**VILLAGE OF DOWNERS GROVE  
REPORT FOR THE VILLAGE COUNCIL MEETING  
MAY 15, 2012 AGENDA**

<b>SUBJECT:</b>	<b>TYPE:</b>	<b>SUBMITTED BY:</b>
Annexation with Rezoning to B-2, Lot Consolidation and Special Use for a drive-through use	<ul style="list-style-type: none"> <li>✓ Resolution</li> <li>✓ Ordinance</li> <li>Motion</li> <li>Discussion Only</li> </ul>	Tom Dabareiner, AICP Community Development Director

A resolution and ordinances have been prepared for annexation, rezoning, lot consolidation and special use for a Walgreens store at the northwest corner of 63<sup>rd</sup> Street and Woodward Avenue.

**To:** Plan Commission  
**From:** Jeff O'Brien, AICP, Planning Manager  
**Subject:** PC-39-11, Annexation with Rezoning to B-2, General Retail Business, Final Plat of Subdivision for Lot Consolidation and Special Use for a drive-through use – Northwest corner of 63<sup>rd</sup> Street and Woodward Avenue  
**Date:** January 9, 2012

**SITE PLAN**

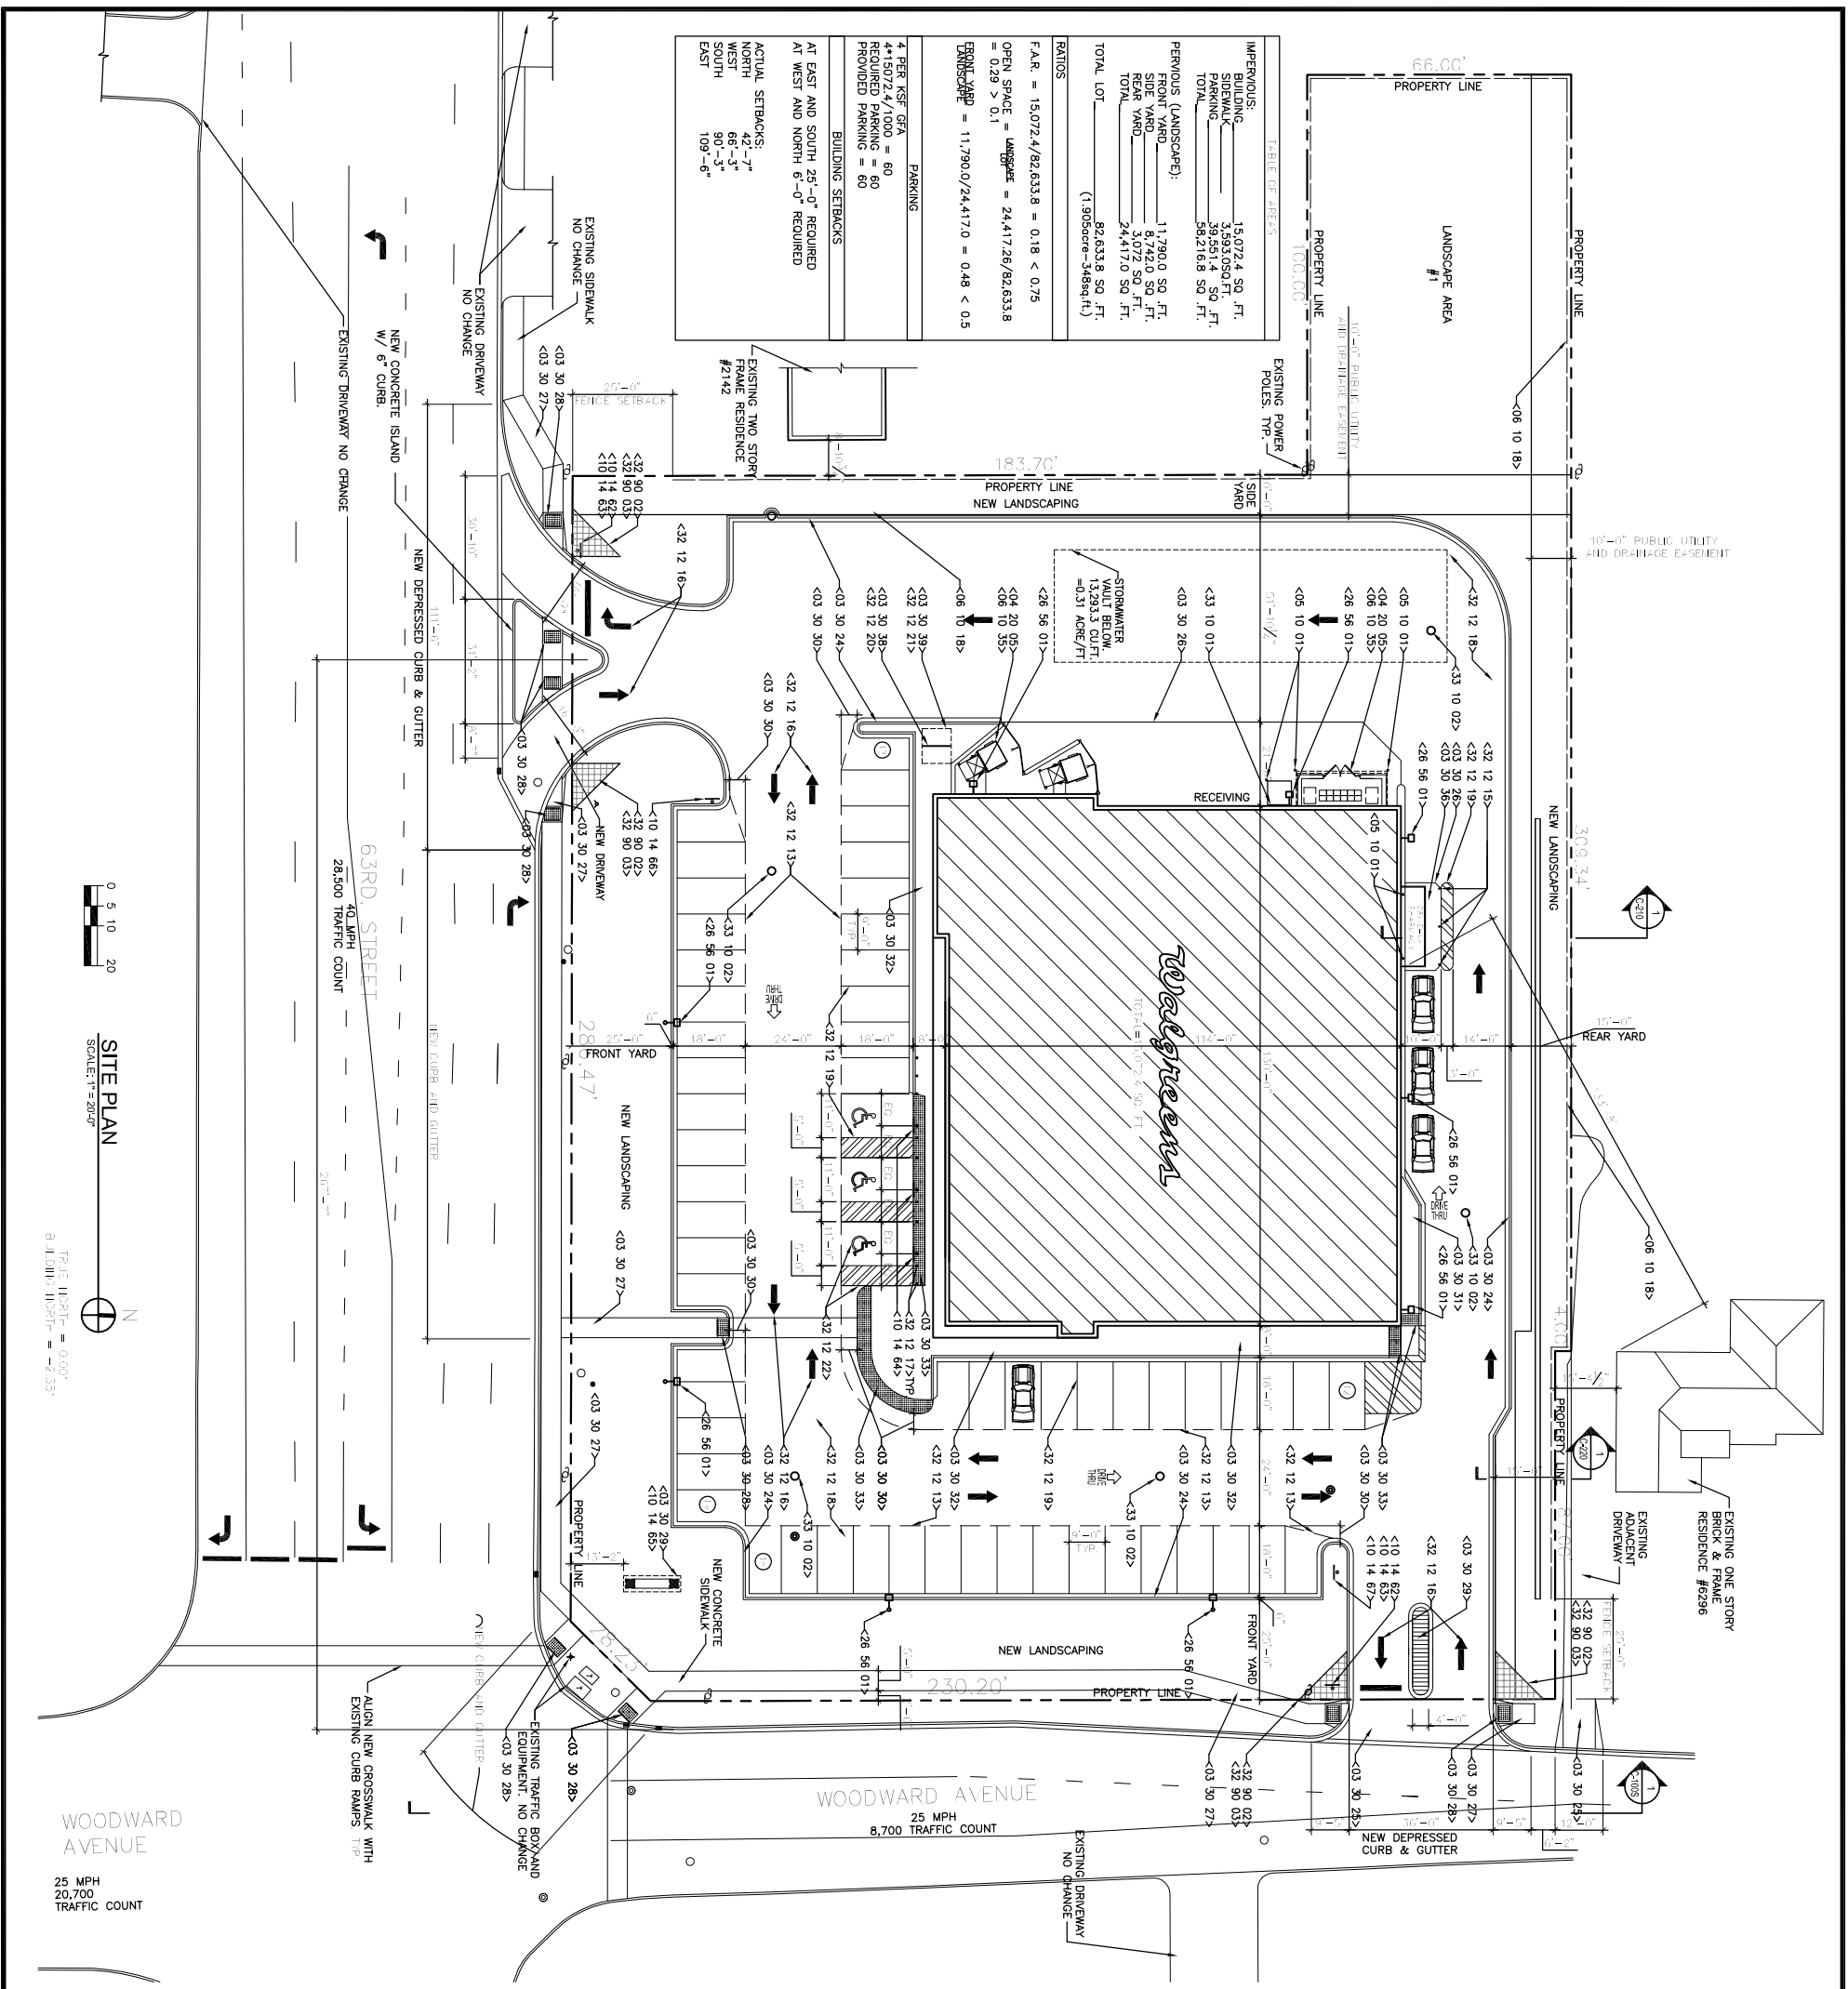
This item was discussed at the February 7, 2012 Village Council meeting. The petitioner has submitted revised plans that show right-in, right-out only on 63<sup>rd</sup> Street and one lane in, one lane out on Woodward, with a sign prohibiting left turns from the site onto Woodward. The conditions of the attached special use ordinance have been changed to reflect this design. Staff recommends approval on the June 5, 2012 Active Agenda. The revised site plans are attached.

AASHTO EXHIBIT 3-2  
 STOPPING SIGHT DISTANCE ON GRADES

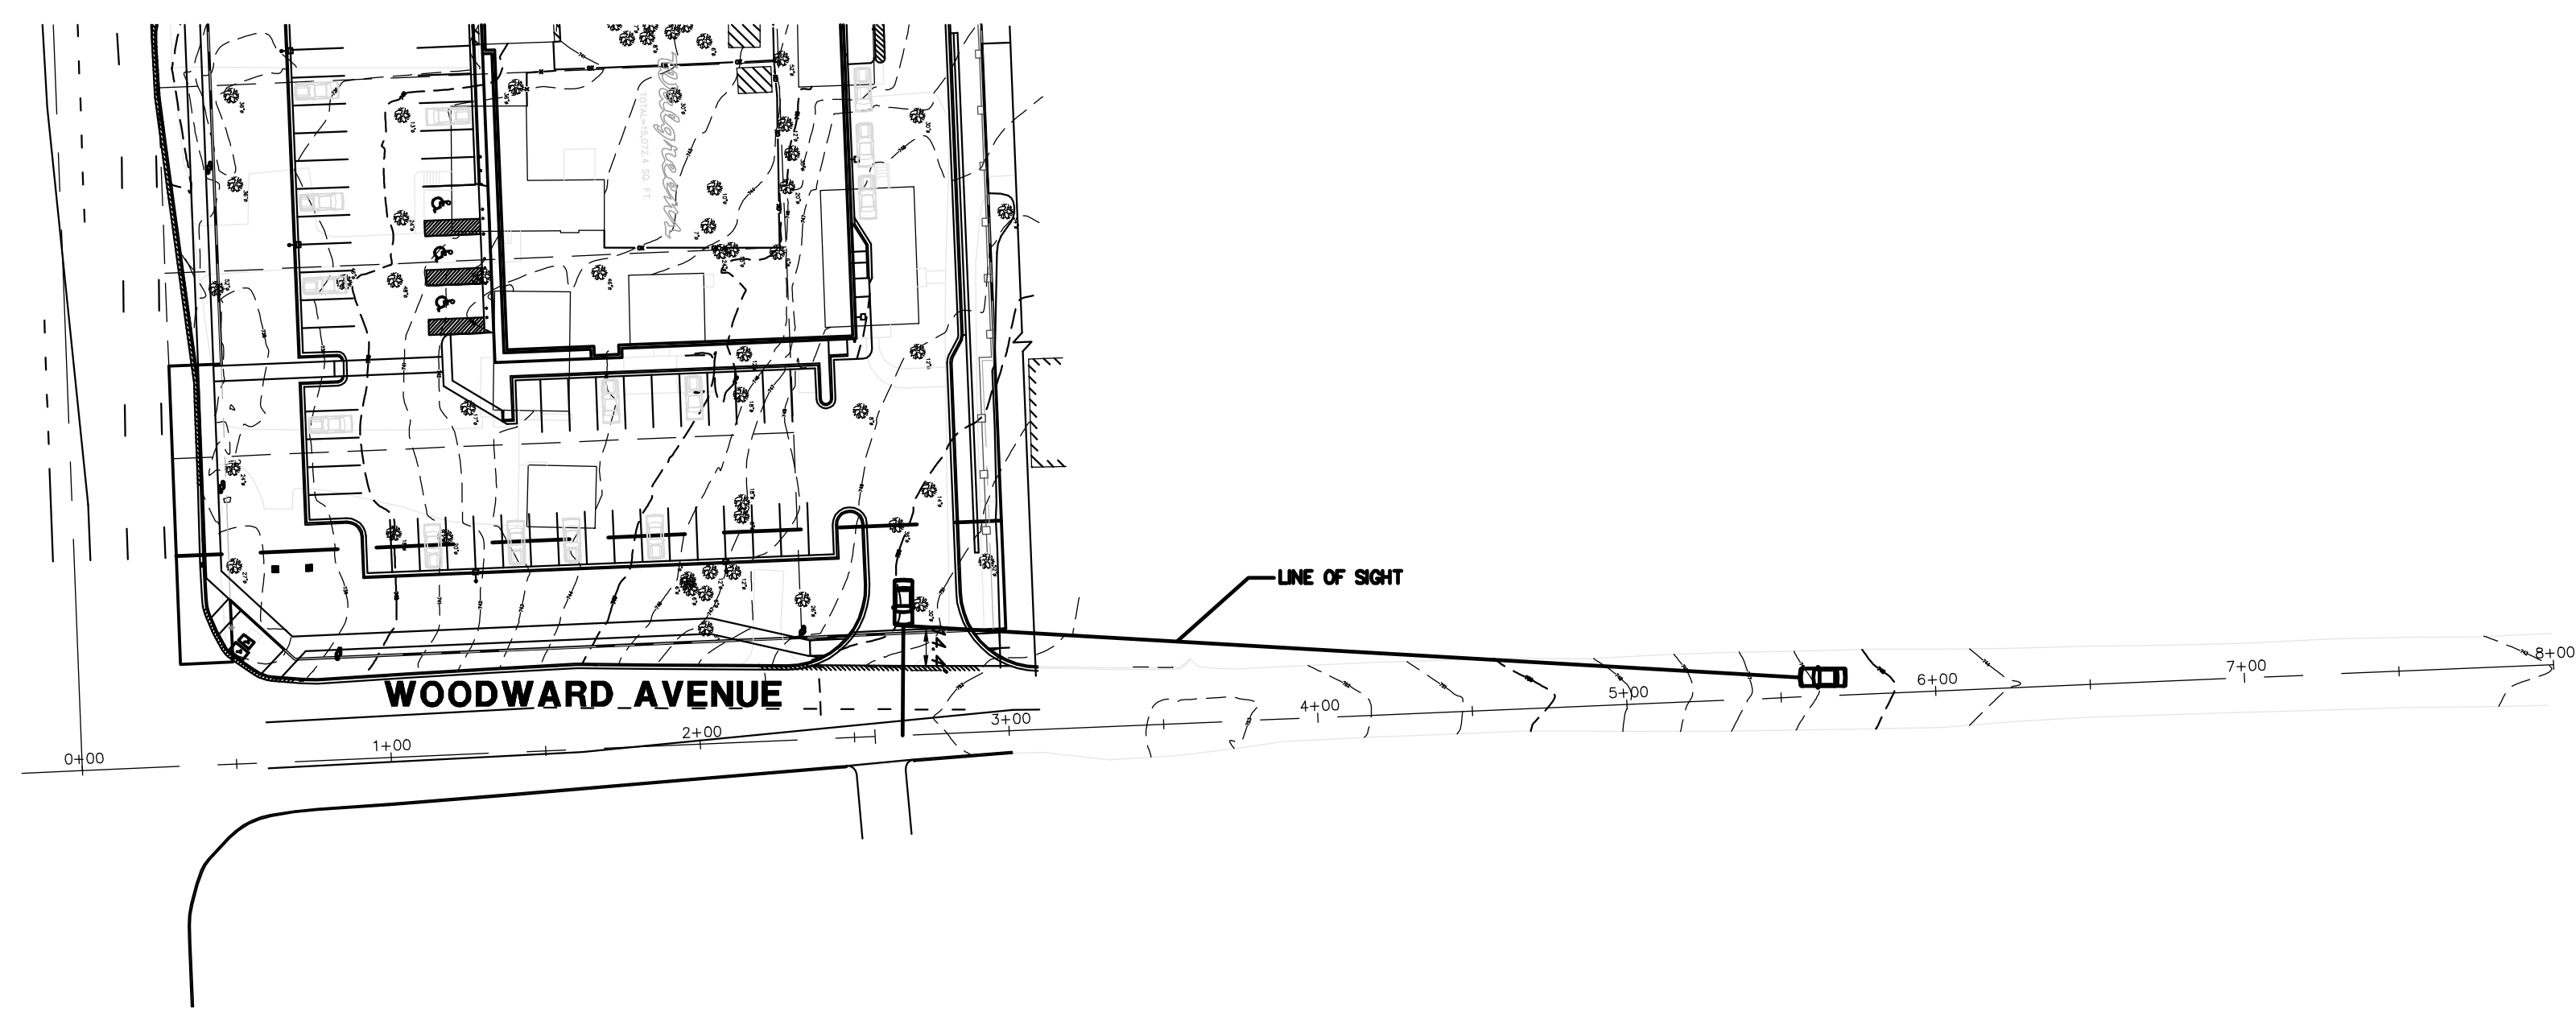
***2. Provide a site distance study for the driveway access on Woodward Avenue***

POSTED SPEED LIMIT ON WOODWARD AVENUE = 25 mph  
 DESIGN SPEED ON WOODWARD AVENUE = 30 mph  
 SLOPE OF WOODWARD AVENUE = 4.8%  
 REQUIRED STOPPING SIGHT DISTANCE = 190 feet  
 ACTUAL STOPPING SIGHT DISTANCE = 290 feet
